Re: Response to Public Comments
Draft Phase I Initial Site Investigation Report
Former Raytheon Facility
430 Boston Post Road
Wayland, Massachusetts (the "Site")
CMG ID 2002-003 RTN 3-22408

On behalf of Raytheon Company (Raytheon), Environmental Resources Management (ERM) has prepared this letter providing responses to comments prepared by CMG Environmental, Inc. (CMG), consultant to the Town of Wayland, regarding the Draft Phase I Initial Site Investigation report (Phase I), dated 12 November 2003. CMG's comment letter, dated 3 December 2003, contains 11 comments. This response letter includes relevant portions of each comment in italics and responses in plain text.

Figure 16 - ORP - pH Diagram for Arsenic in Groundwater
 Former Raytheon Facility - Wayland, MA

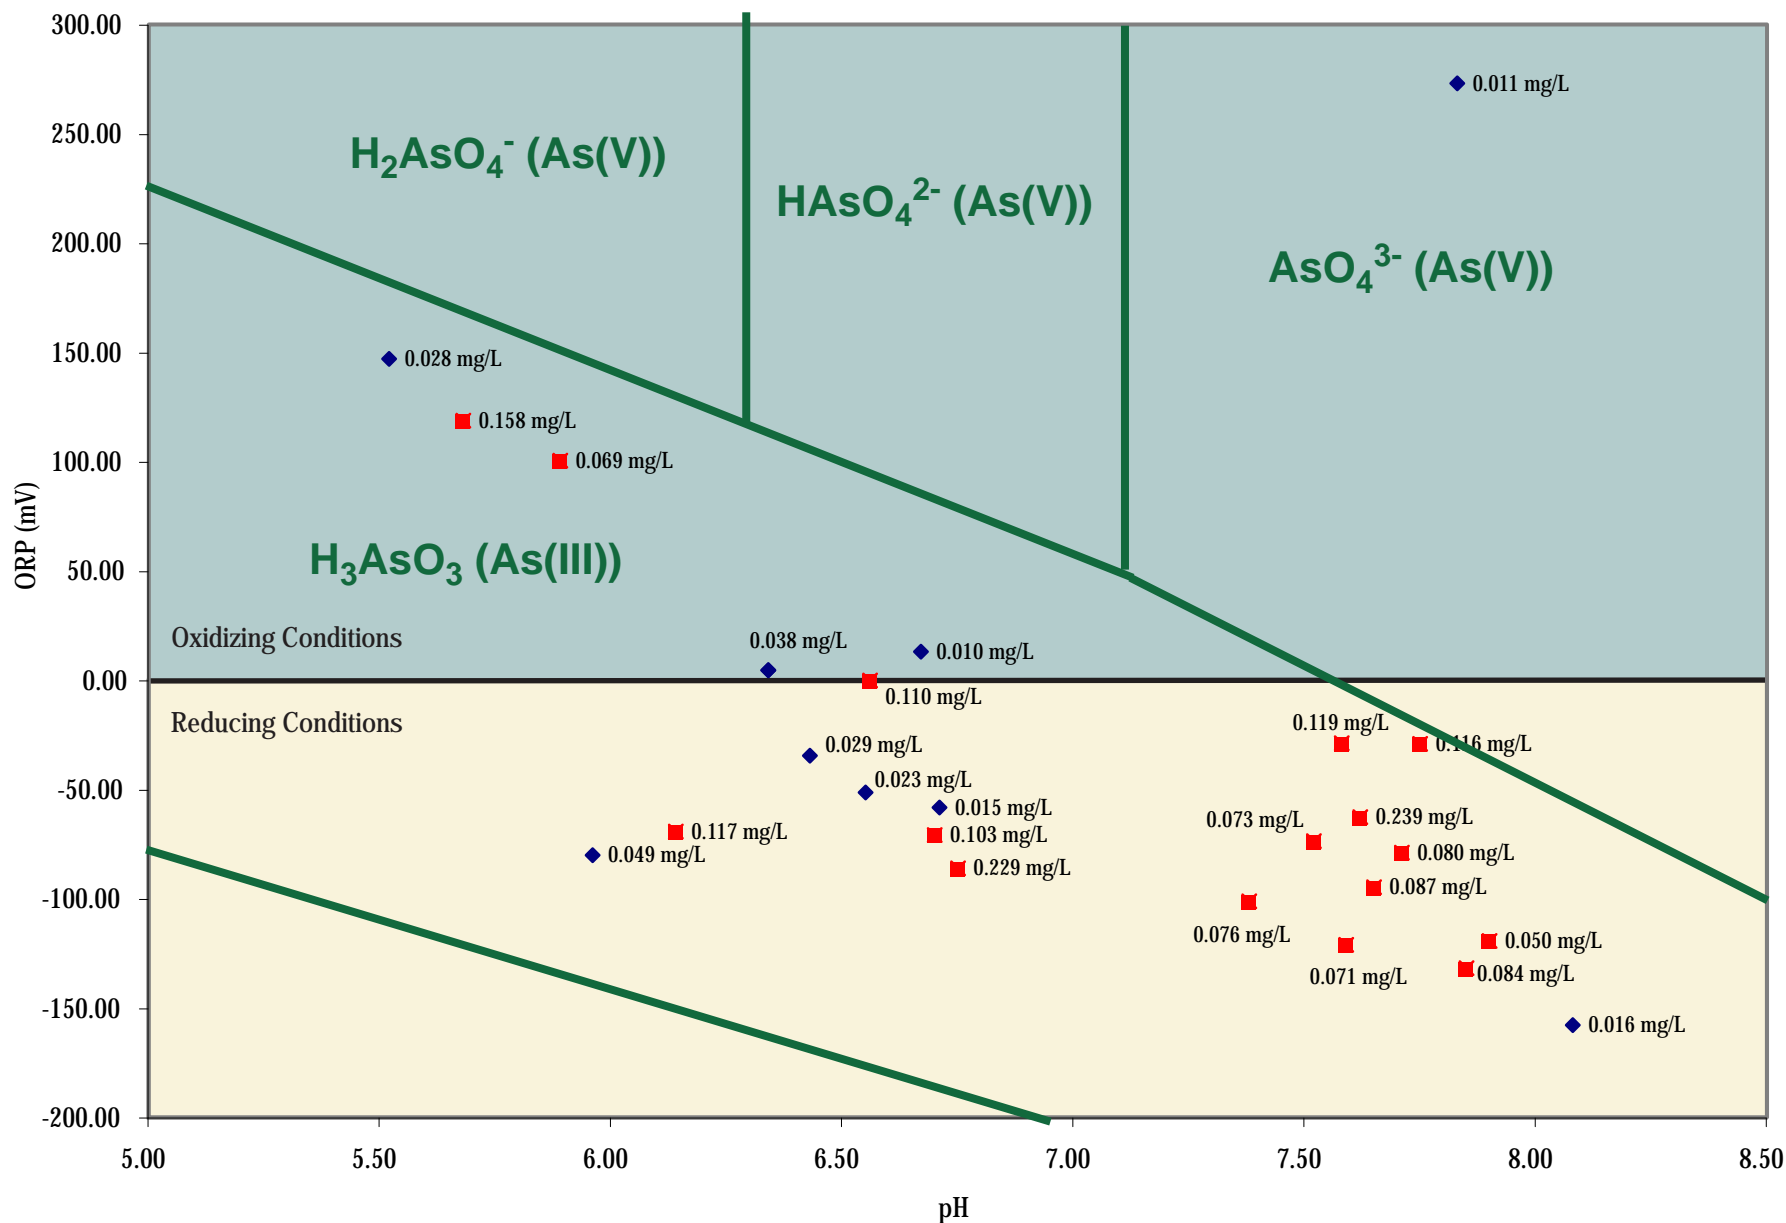
VII) On page 32 of the ISI Report, ERM discusses relationships between arsenic concentrations in groundwater, pH, and oxidation-reduction potential (ORP). This discussion refers to Figure 16. ERM states that "concentrations of arsenic above RCs were most frequently detected in groundwater samples having relatively low ORPs (i.e., less than 0.00 millivolts (mV))." While this may be true, it implies a correlation between negative ORP and elevated arsenic concentrations.

We have done a statistical analysis on groundwater arsenic results presented in Table 11 of the ISI report versus ORP and pH field screening values presented in Tables 6C and 6B, respectively. (The field parameter measurements for September 2002 groundwater sampling are not given in the current ISI report - we obtained these values from Tables 3a [pH] and 3e [ORP] presented in the December 30, 2002 Phase IV report for RTN 3-22408.) Our analysis of 26 data points indicates an R2 correlation coefficient of 0.0239 for arsenic concentrations versus ORP, and an R2 value of 0.0054 for arsenic concentrations versus pH (see attached Figure 2). This indicates there is no statistical correlation between ORP and arsenic concentrations or pH and arsenic concentrations.

Wayland requests that ERM consider other possibilities to explain the observed elevated arsenic concentrations in Western Area groundwater at the Site. While their conceptual model of iron hydroxide-mediated release of arsenic oxy-anions under reducing conditions seems plausible (see also Section 5.4.5 [Western Area, page 37] of the current ISI Report), our statistical analysis suggests this may not be the actual mechanism involved.

Because of the abundance of forms of arsenic and the complex Eh-pH relationship, one would not expect to find any sort of linear relationship between arsenic concentration and either pH or Eh. The reason for this is that different forms of arsenic, each with a pH-dependent solubility, could be mixed together in the data set. For instance, the range of oxidation-reduction potential (ORP) on Figure 16 of the Phase I report is from -160 to +275 millivolts (mV), and the range of pH is from 5.5 to 8.1. Over this range, there are at least three stable arsenic forms: mono-ortho arsenate, di-ortho arsenate and arsenite. ERM did not indicate in the report, nor does the scientific literature suggest, that there is a linear relationship between arsenic concentrations and ORP/pH, but rather indicated that arsenic was significantly more soluble under reducing (low ORP values) and basic (high pH) aquifer conditions.

ERM did not present a more detailed evaluation of this relationship in the Phase I report, because we did not deem it appropriate or necessary at this stage of the MCP process. With respect to the statistical analysis conducted on the data by the Town, ERM does not believe that linear regression is an appropriate statistical tool to evaluate the relationship between arsenic concentration and ORP and/or pH, as noted above.

Eh-pH diagrams are commonly used to evaluate relationships between metal (e.g., arsenic) solubility relative to groundwater geochemistry (i.e., ORP and pH). The form of ERM's Figure 16 is much more in keeping with the geochemical understanding of arsenic behavior. The trend of the plotted points follows the general trend of the zone of arsenite (As (III)) stability. To illustrate this, we have superimposed the Eh-pH diagram for arsenic at 25°C and 1 atm, based on the diagram published in Ferguson and Gavis (1972)¹. Clearly, all but one data point falls in the reduced zone (i.e., the region in which soluble As(III) is stable). In summary, the solubility of arsenic as a function of Site geochemistry will be evaluated in more detail during the Phase II. This evaluation will be conducted to the extent necessary to support the assertion that the arsenic in groundwater is consistent with background.
